SEEGER HOMES INC. - SALES OFFICE

SITE DEVELOPMENT PLANS
LOT 3, APPALOOSA HIGHWAY 24 SUBDIVISION

SALES OFFICE - SPECIAL USE
DEVELOPMENT PLAN

SHEET NO. C-01
DATE: 05/25/18
PAGE NO. 1 OF 1

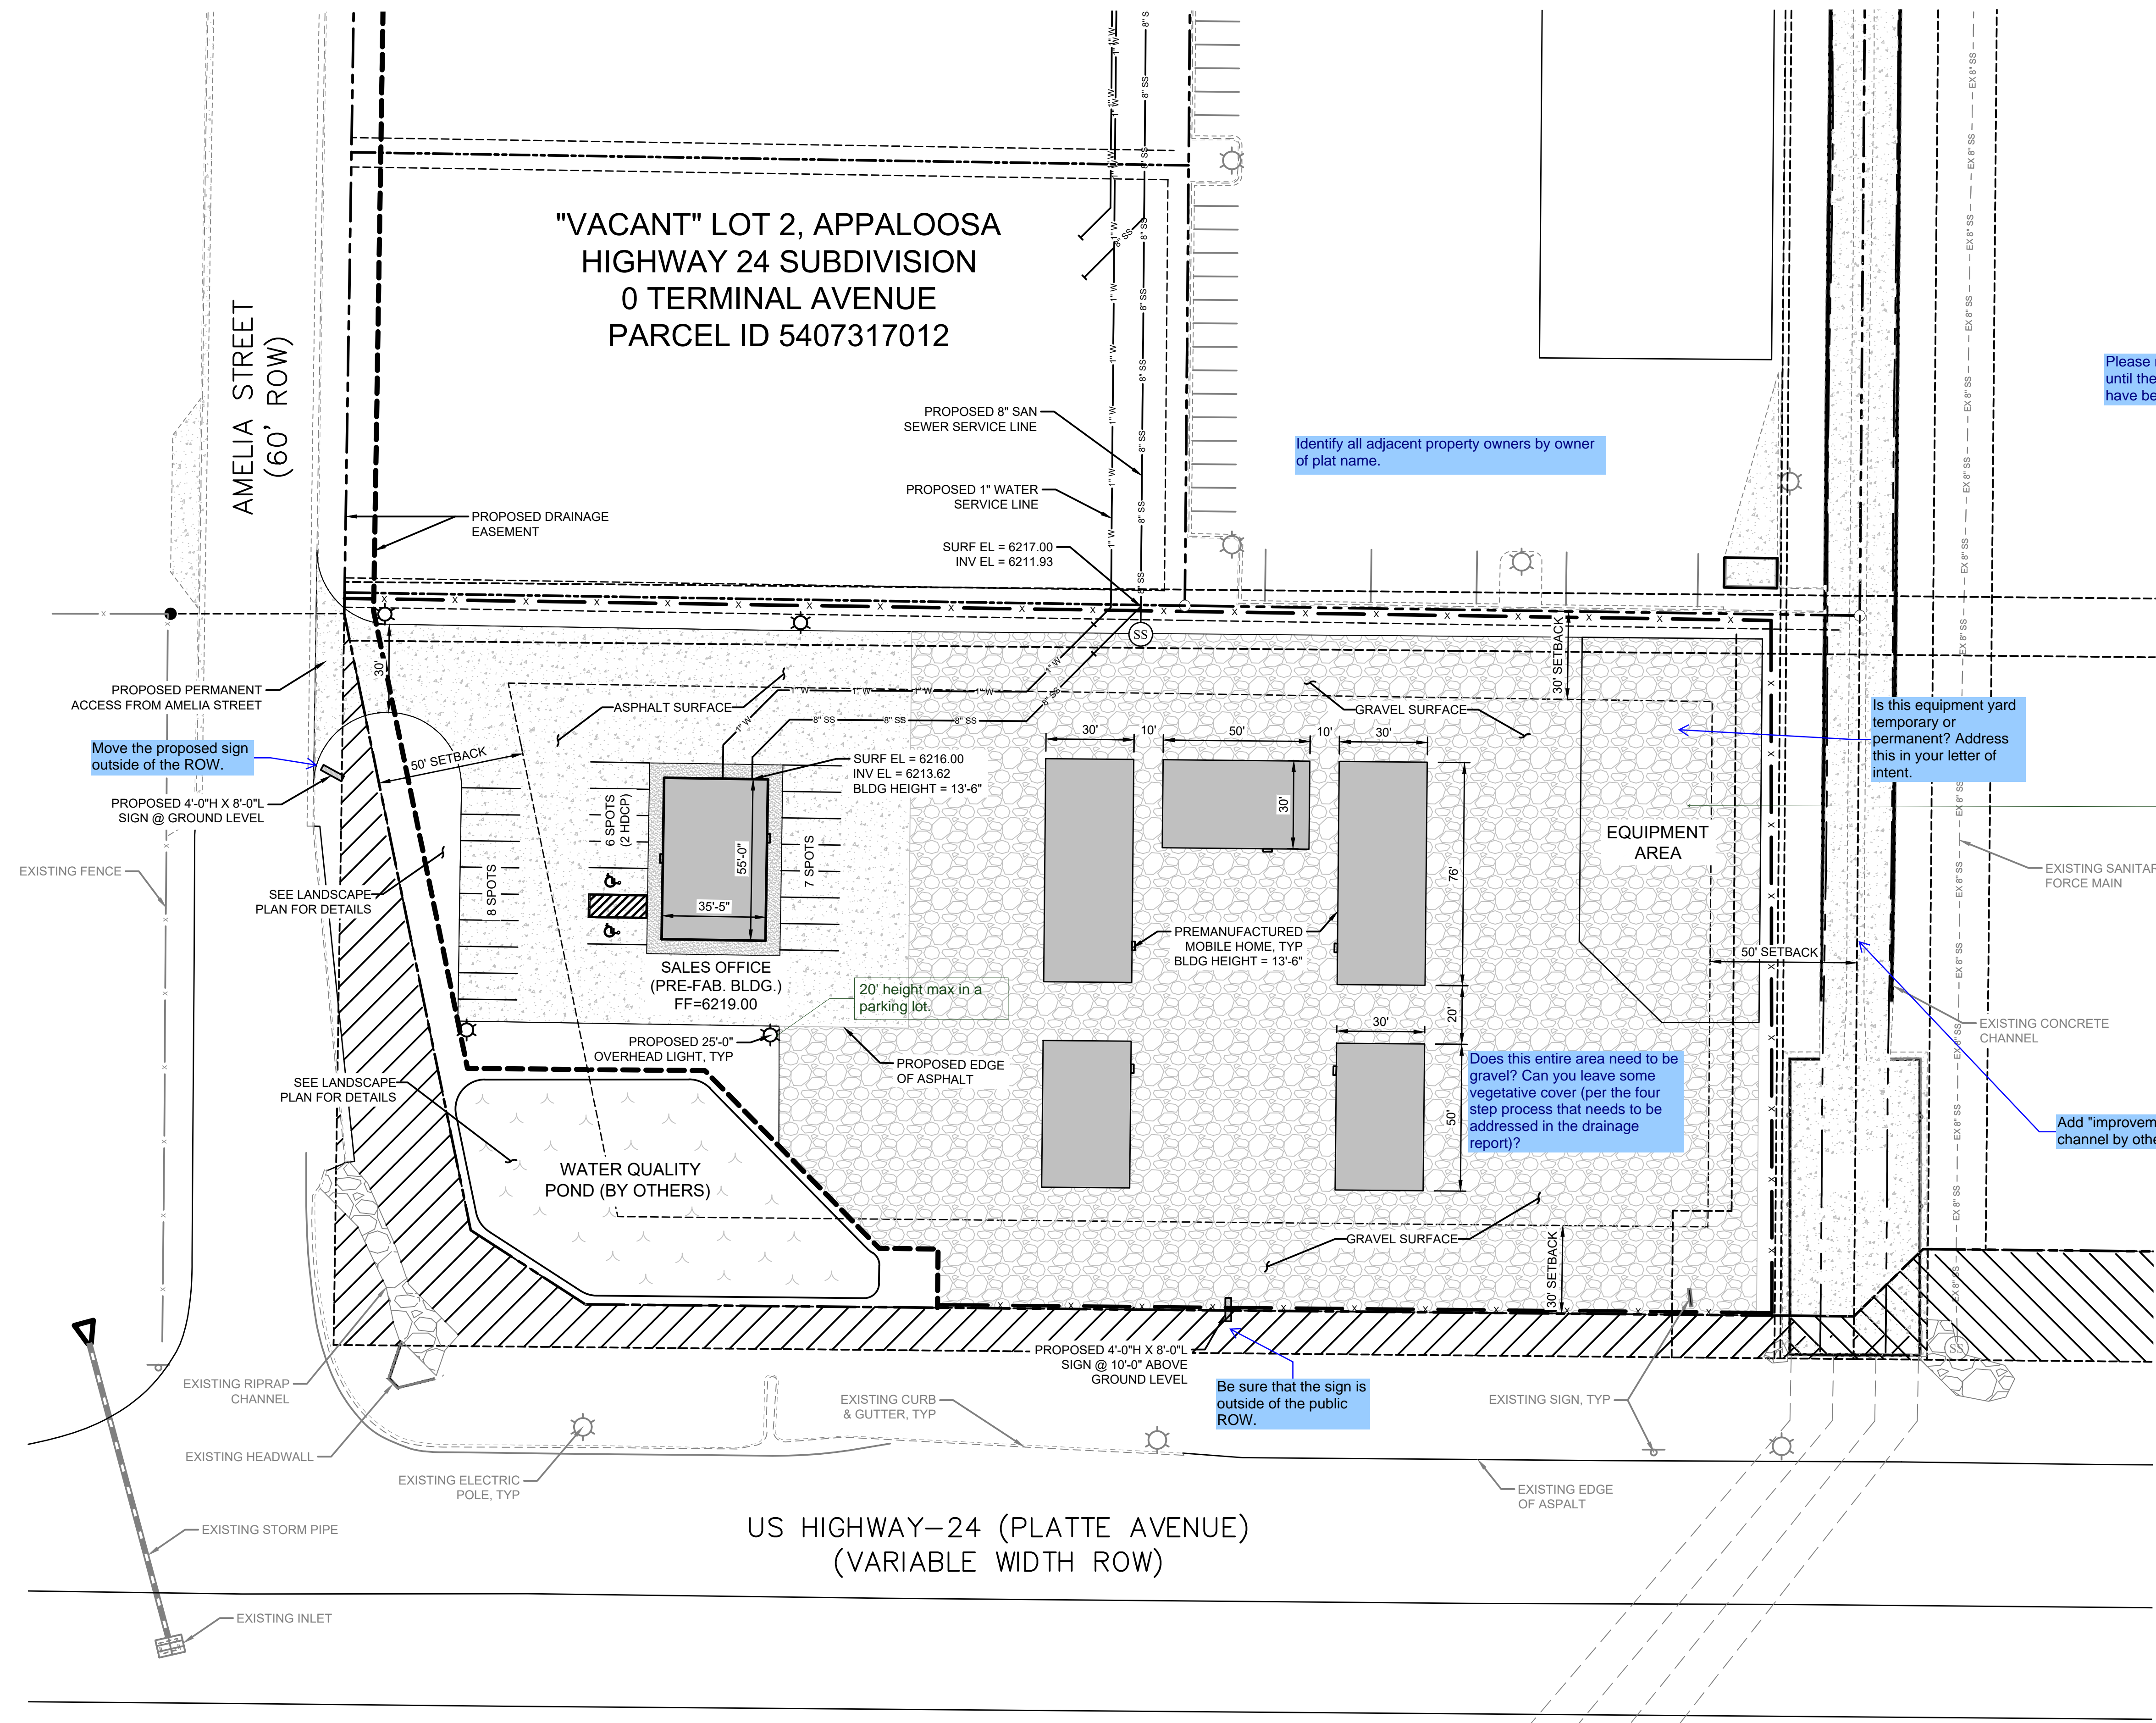
Please note that CO will not be given to the sales office until the channel improvements and the water quality pond have been completed.

Identify all adjacent property owners by owner of plat name.

Move the proposed sign outside of the ROW.

Is this equipment yard temporary or permanent? Address this in your letter of intent.

This area must comply with the Outside Storage standards in Chapter 5.2.38 of the El Paso County Land Development Code.

Does this entire area need to be gravel? Can you leave some vegetative cover (per the four step process that needs to be addressed in the drainage report)?

Be sure that the sign is outside of the public ROW.

Add PCD file no. AL1811

Add "improvements to channel by others"

20' height max in a parking lot.
